Access Compliance Report

Public Rights-of-Way

Intersection ID: 54220	Main Street: SOUTH_REA_PARK_LN	Cross Street: SANDY_ROCK_PL	Location: NE
ADA ID: AF04603DED5A	Ramp Type: Perp	Initial Pass/Fail: Pass	Overall Compliance: No
Codes/Mitigation Info/Possible Solution			Severity Score: 2.5
			Field Measurements/Component Compliance

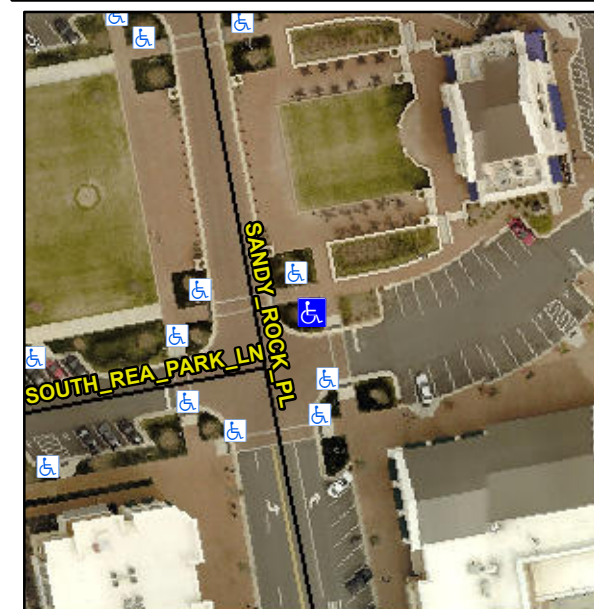
R305.1.4

Remove & Replace Detectable Warning System.
